# 1984 Corvette: Recall: Front Brake Caliper Bracket Bolt

**Subject:** PRODUCT SAFETY FRONT BRAKE CALIPER BRACKET BOLT

**Model and Year:** 1984 CHEVROLET CORVETTE MODELS (VIN: E5100001 - E5109828)

**Bulletin Number:** 84-C-02 - (06/01/1983)

## PARTS INFORMATION

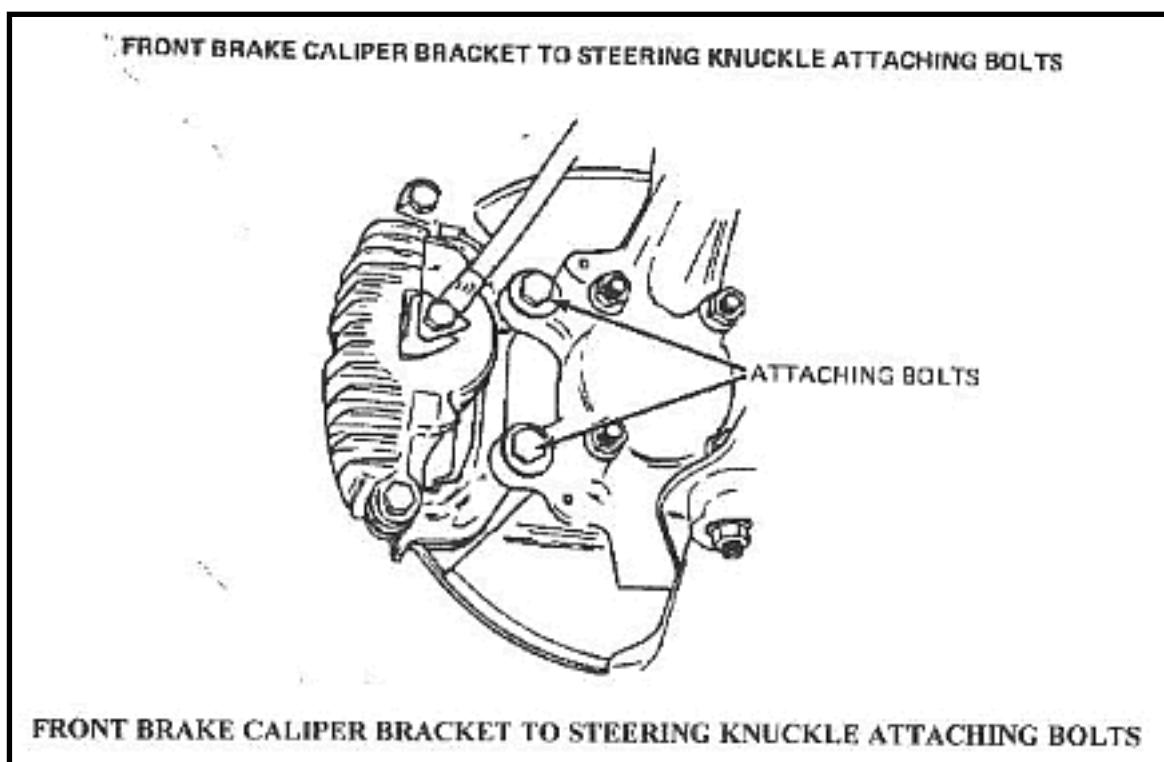
GENERAL MOTORS HAS DETERMINED THAT A DEFECT WHICH RELATES TO MOTOR VEHICLE SAFETY EXISTS IN CERTAIN EARLY PRODUCTION 1984 CORVETTES. THE FRONT BRAKE CALIPER BRACKET TO STEERING KNUCKLE ATTACHING BOLTS MAY LOOSEN AND FALL OUT. THE FRONT BRAKE CALIPER MAY THEN BECOME PARTIALLY DETACHED FROM THE KNUCKLE ASSEMBLY AND MAY CAUSE THE WHEEL TO LOCK. SHOULD THIS OCCUR WHILE THE VEHICLE IS IN MOTION, IT COULD RESULT IN A LOSS OF CONTROL, A VEHICLE CRASH COULD OCCUR WITHOUT PRIOR WARNING.

TO PREVENT THE POSSIBILITY OF THIS CONDITION OCCURRING, CHEVROLET DEALERS ARE TO REPLACE THE FRONT BRAKE CALIPER BRACKET TO STEERING KNUCKLE ATTACHING BOLTS ON ALL INVOLVED VEHICLES IN ACCORDANCE WITH THE SERVICE PROCEDURE AS OUTLINED IN THIS CAMPAIGN BULLETIN.

14079998 4 FRONT BRAKE CALIPER BRACKET TO STEERING KNUCKLE ATTACHING BOLT

**IMPORTANT: THE NEW BOLT P/N 14079998 CAN BE IDENTIFIED BY THE ORANGE COLORED ADHESIVE PATCH MATERIAL ON THE BOLT THREADS.**

1. RAISE HOOD.
2. REMOVE THE UPPER CALIPER ATTACHING BOLT.
3. USING THE NEW 3/8 IN. CYLINDRICAL WIRE BRUSH PROVIDED, FIRST THOROUGHLY CLEAN THE BRUSH WITH 1,1,1 TRICHLORETHANE SOLVENT; LET DRY.
4. CLEAN THREADS IN THE UPPER CALIPER ATTACHMENT BY THREADING THE BRUSH THROUGH THE THREADS AS FAR AS POSSIBLE, THEN REMOVE BY REVERSE THREAD- ING. THIS STEP MUST BE PERFORMED TO REMOVE RESIDUAL TEFLON NO MATTER HOW CLEAN THE THREADS APPEAR.
5. BLOW OUT THREADS WITH AIR GUN.
6. INSTALL NEW BOLT PROVIDED, P/N 140799998, AND TORQUE TO 97 N.M (70 FTL.LB.).
7. REPEAT THE PROCESS FOR THE LOWER CALIPER ATTACHING BOLT.
